DISCRETIONARY REVIEW ABBREVIATED ANALYSIS

HEARING DATE: SEPTEMBER 23, 2021

Record No.: 2021-000269DRP-02
Project Address: 3669 21ST Street
Permit Applications: 2020.1228.1772 and 2020.1226.1735
Zoning: RH-1 [Residential House, One-Family]
40-X Height and Bulk District
Block/Lot: 3620 / 054
Project Sponsor: John Maniscalco
442 Grove St.
San Francisco, CA 94102
Staff Contact: David Winslow – (628) 652-7335
david.winslow@sfgov.org

Exhibit 1, detail of 3669 21st Street proposed site plan front elevation, sheet A-5, showing scale of project relative to my property, at left.

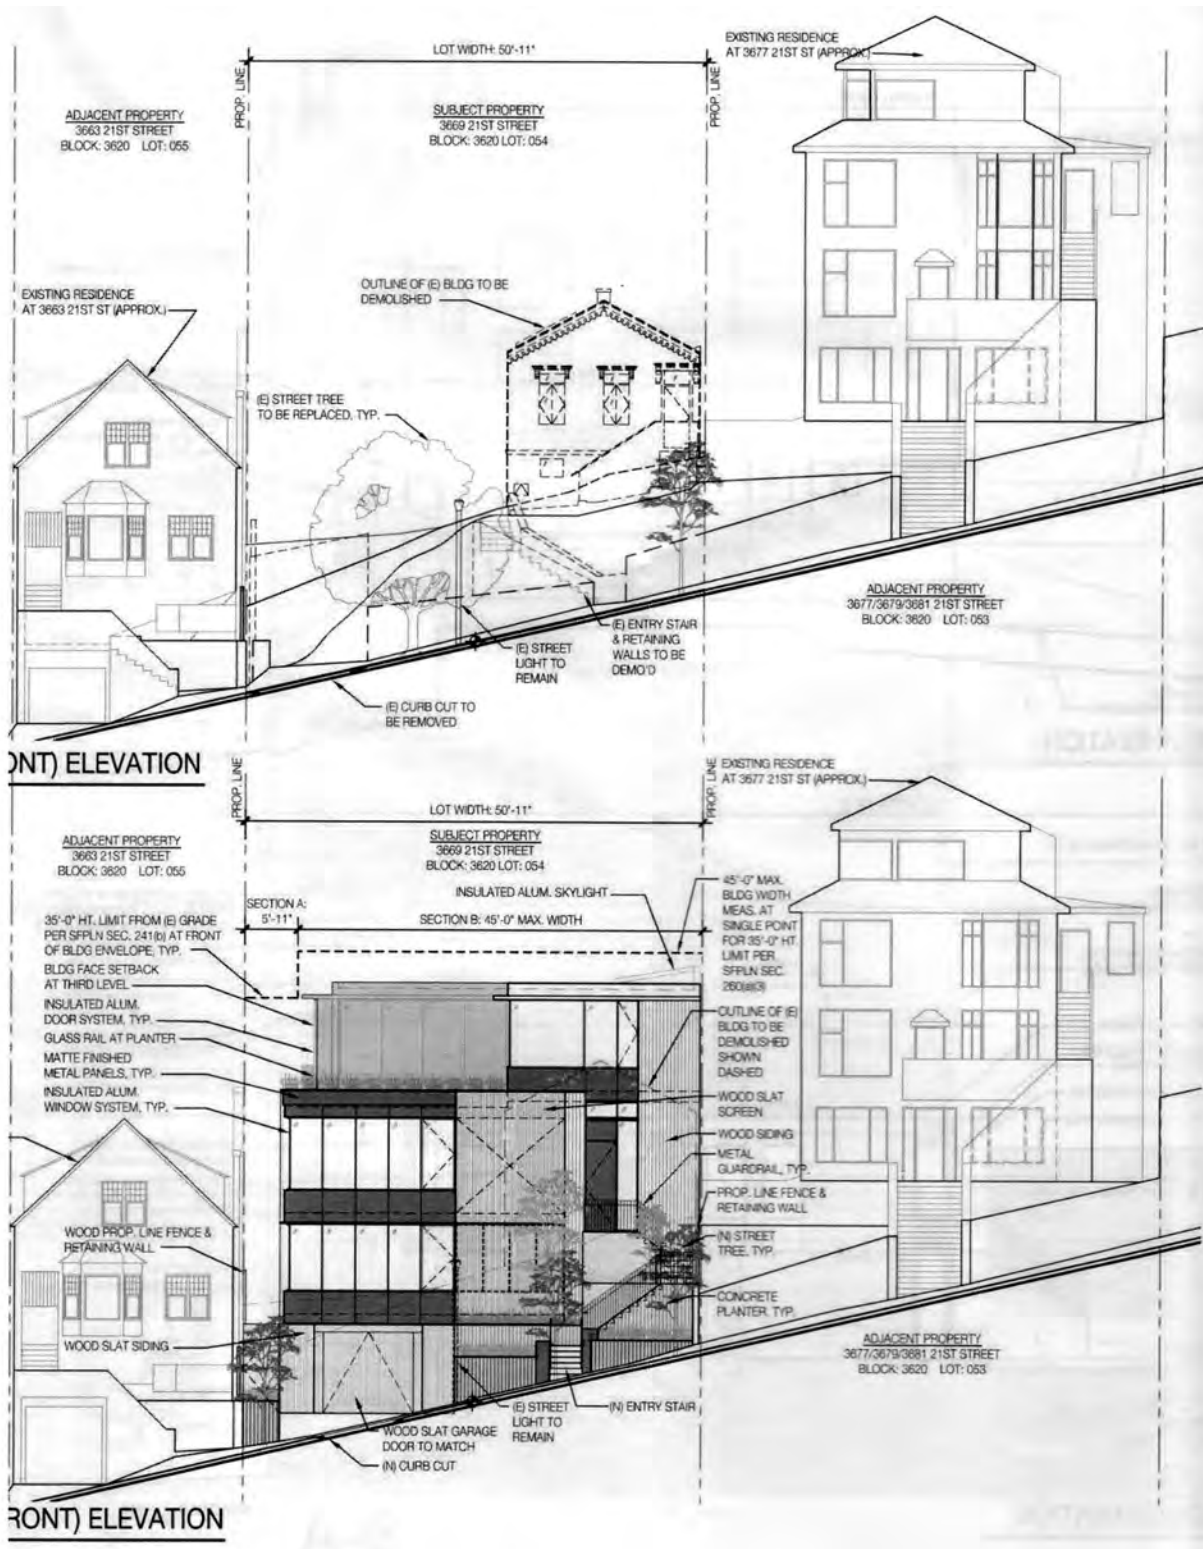
“Articulate buildings to minimize impact on light and privacy.” Specifically, loss of light to side facing windows and loss of privacy from the roof deck at the southeast corner of the proposed building.

Exhibit 3, detail of 3669 21st Street proposed site plan front elevation, sheet A-5, with superimposed line showing roof-to-roof relative position and potential shading.

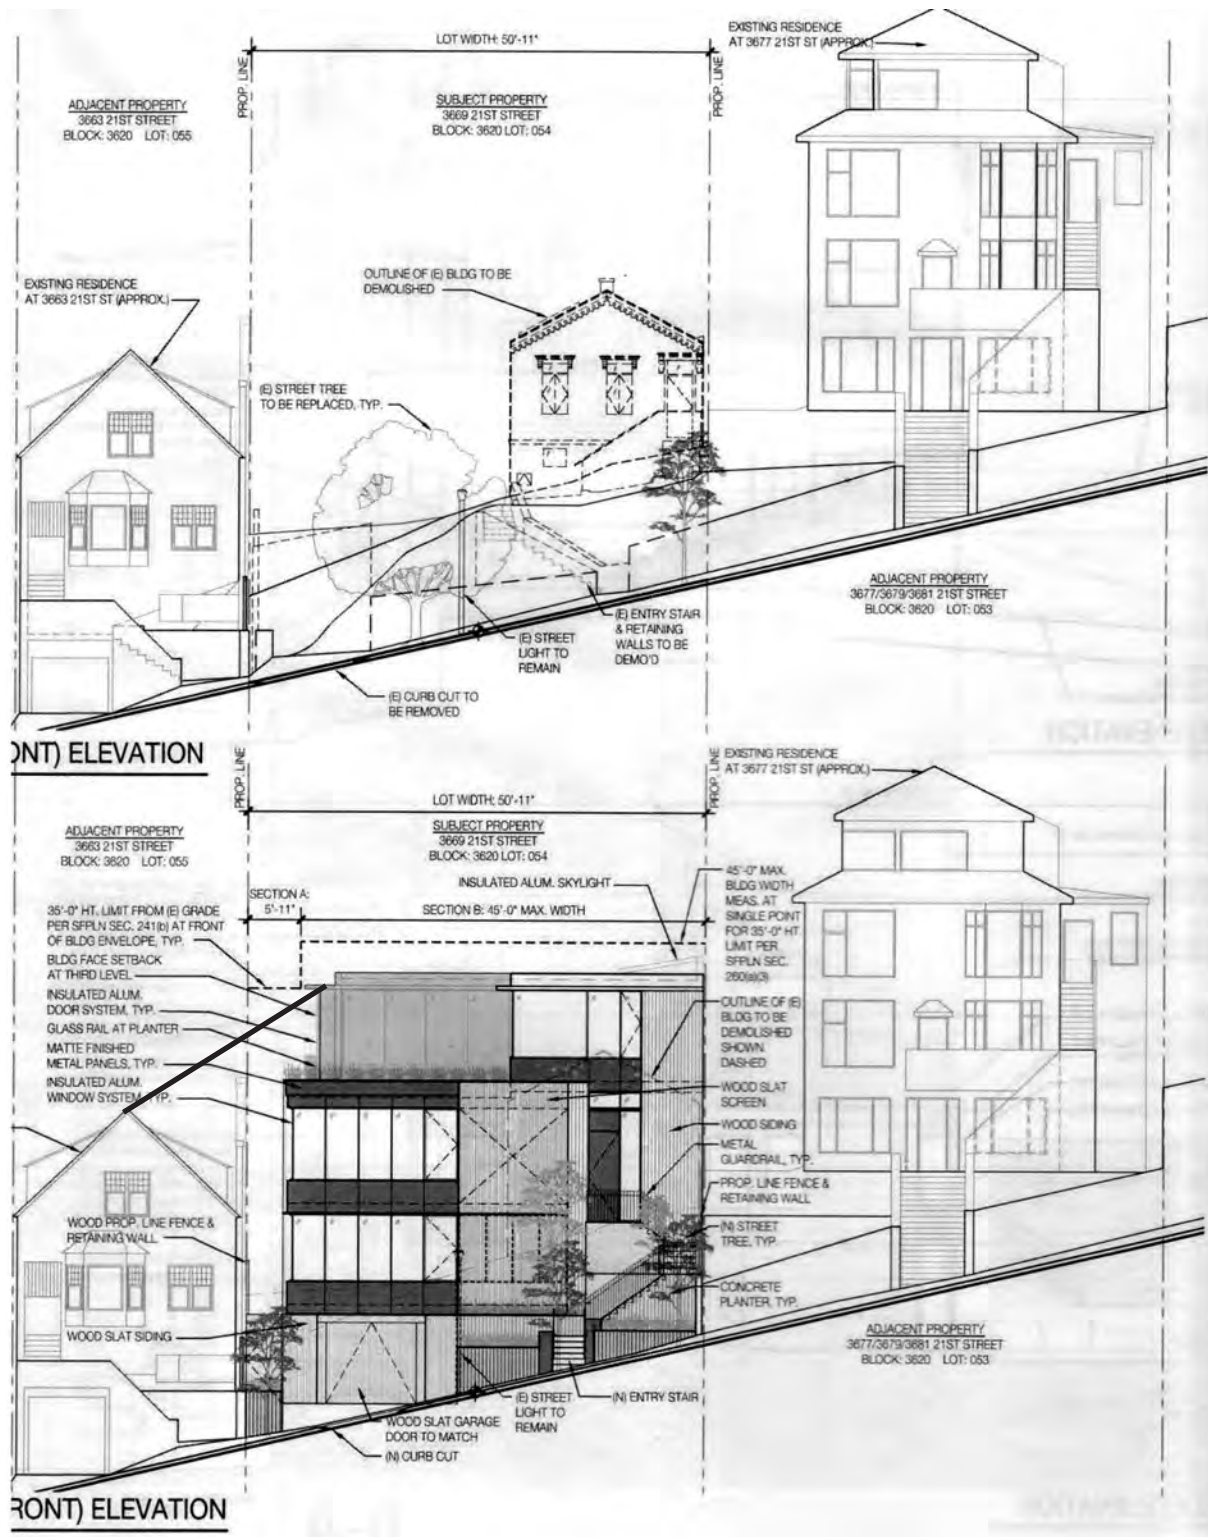
1. Step back the upper floor to allow direct light to come in during late afternoon hours.
2. Use privacy glass in the windows facing the bathroom and studio.
3. Provide screening on the deck or along the fence line.

Exhibit 5, detail of 3669 21st Street proposed site plan, sheet A-1, line superimposed showing view from rear deck to my property windows, at left

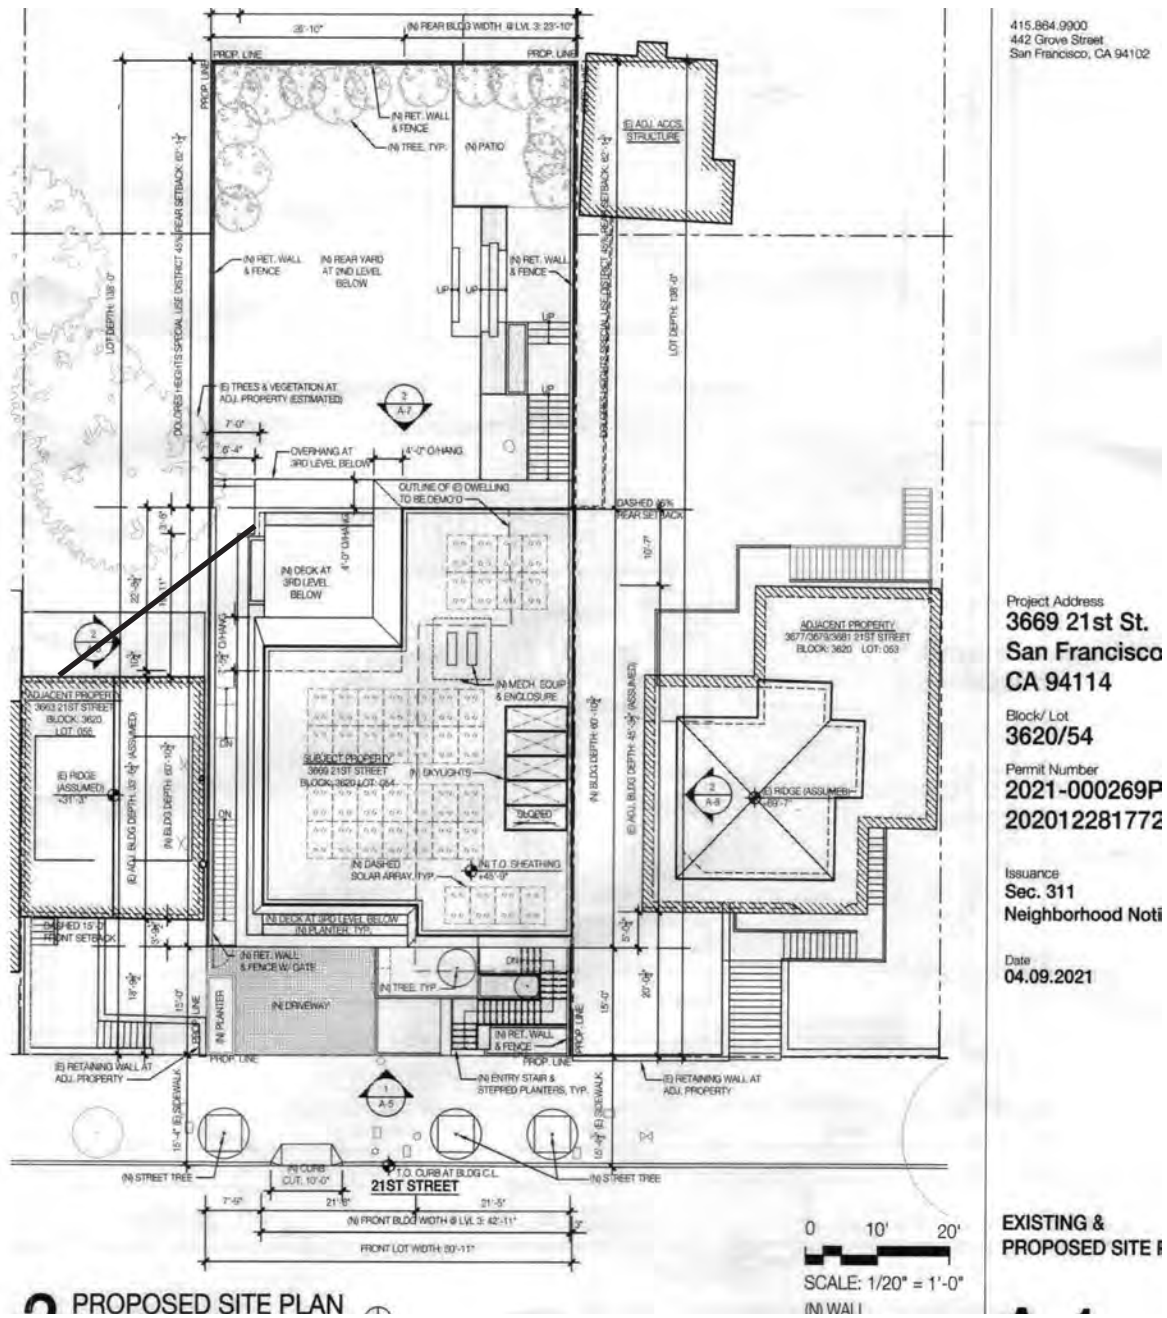
3. Privacy issues from the roof deck located at the southeast side of the property: Provide screening on the deck or along the fenceline.

The massing at the southeast corner of the third floor - such that the rear building wall of the third floor aligns with the adjacent neighbor to the east - is appropriate to maintain adequate access to light and mid-block open space. However, the rear deck at the third level, which is set back 7' may still present an unnecessary and undesirable burden on the neighbor's privacy because of the height, size, location and relationship of the deck to the adjacent neighbor. Staff recommends additional buffers from the east edge of the deck to provide privacy.

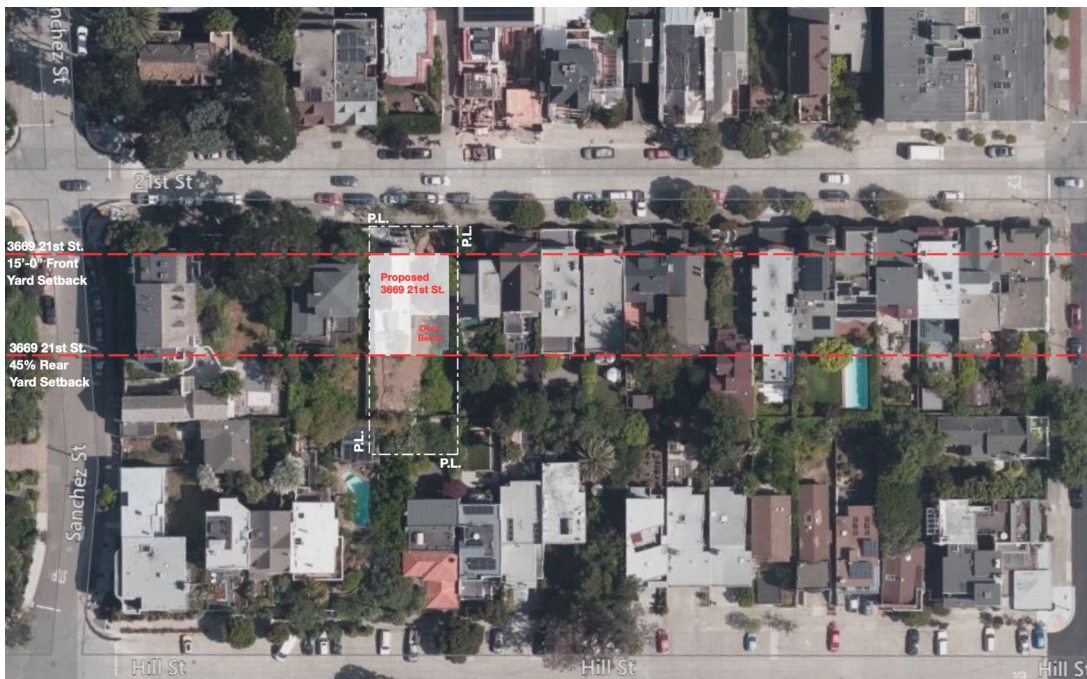
Claim 1. "The mass of proposed structure combined with the depth of the lot creates a noteworthy and unwelcome intrusion in to the green space associated with adjacent properties and the neighborhood."

- The project as designed is subject to and fully compliant with the increased standards of the Dolores Heights Special Use District, which increases the RH-1 rear yard setback from 25% to 45%.

- Despite the increased lot depth, the proposed house extends no further into the rear yard than the existing house. The existing rear yard setback is unchanged.

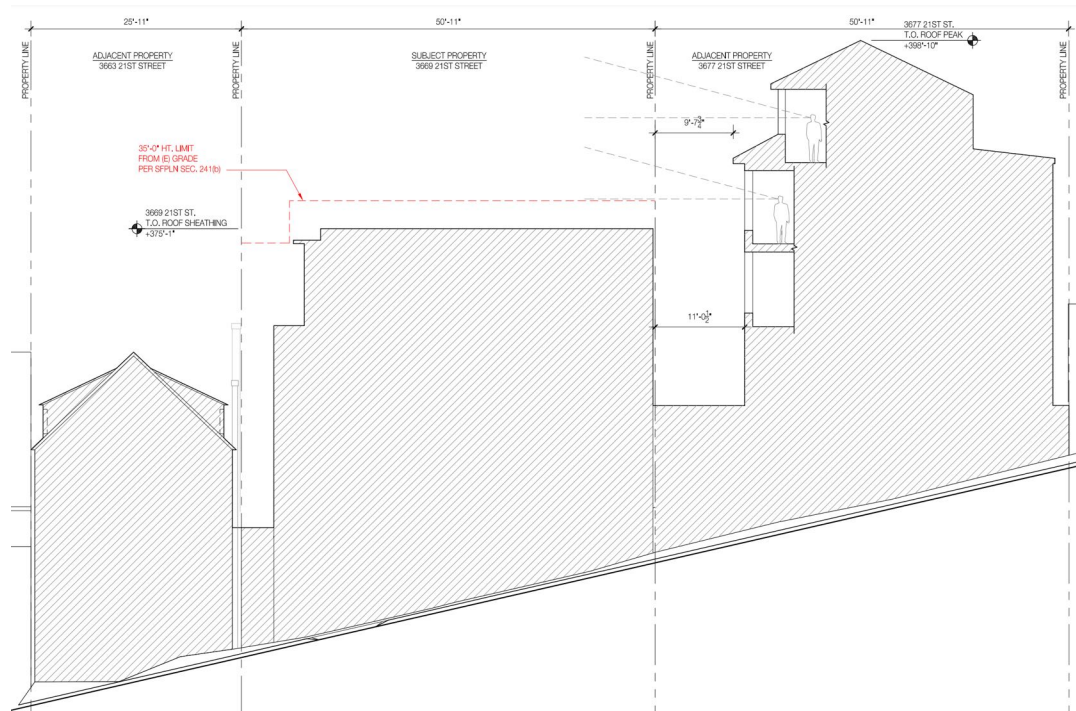
Claim 2. The proposed project will also significantly reduce natural light exposure for two of three residential units (3677 and 3679) located immediately to the west of the subject property.

- The proposed projects sits to the east and downhill from the DR requestor's much taller property, with a roofline that is two full stories lower than the DR requestor's building. Additionally, there is 11 feet of separation between structures which protects full access to light and air for the DR requestor.
- Access to light, air, and views are unchanged for the **upper two stories** is unchanged/unaffected.

- Access to light and air for the **lower windows** is also minimally affected and guaranteed by the 11 feet of separation between structures. To study the concerns of the DR requestors, a solar study was performed. That study, shared with the DR requestors and included here (EXHIBIT A), showed that:
 - As the windows are east-facing, under idealized conditions, they have potential access to light for a period from "first light" until midday, at which point the sun has moved beyond the corner of your house.
 - Given sponsor's downhill position and the separation of more than 11 feet between structures, any shadowing clears those windows within the early hours of the day, leaving them with direct solar access from approximately 9:35 am onwards (on average) for most times of the year.

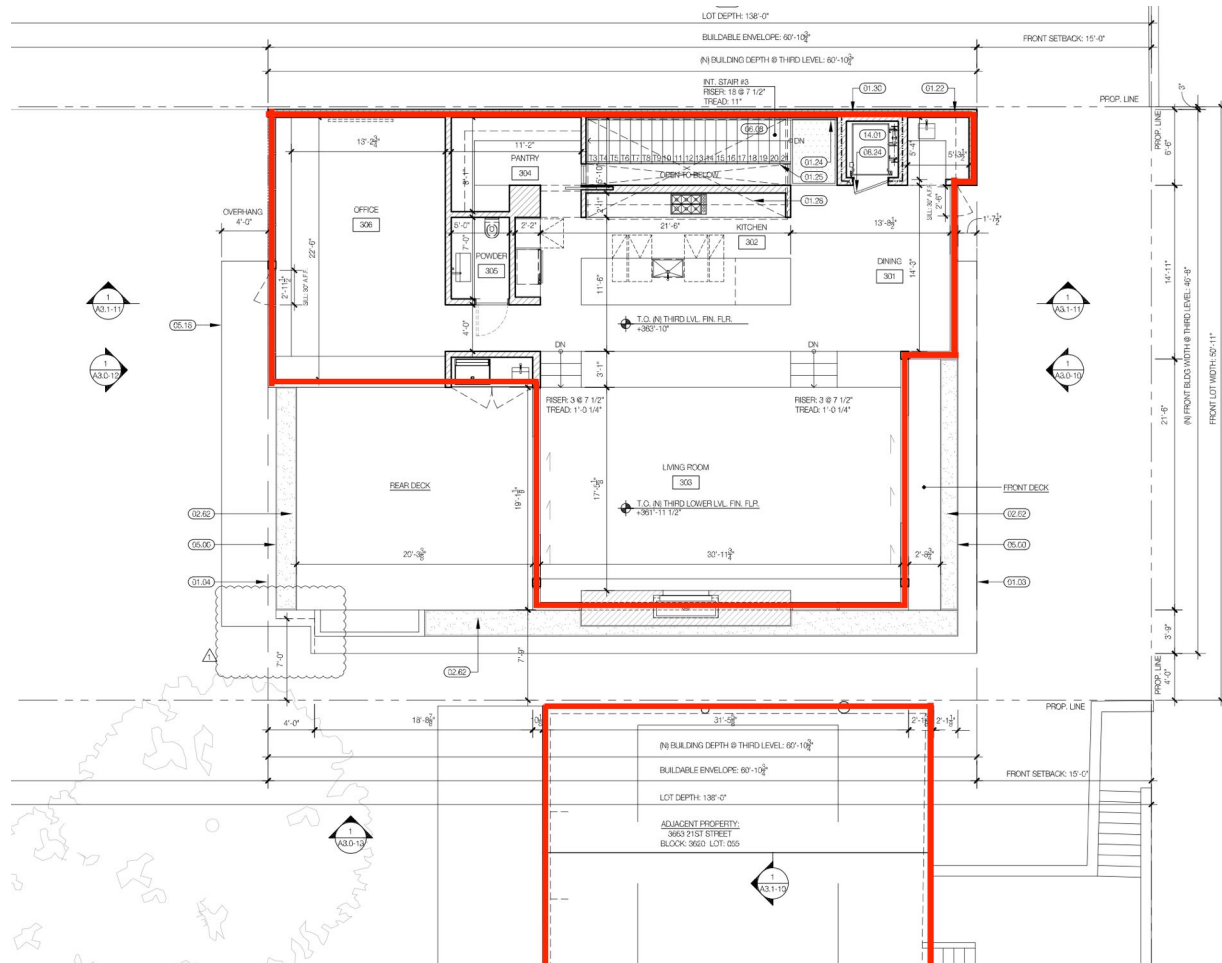
Claim 1. Reduced light and privacy into his west-facing dormer windows

- Mr. Holub has two small west-facing dormer windows (a bathroom and a "studio"). Both windows have been largely obscured by large trees to the west for years.

- The southern dormer window is glazed with patterned obscure glass. The northern dormer window is also a textured obscure glass and has typically been covered from the interior.
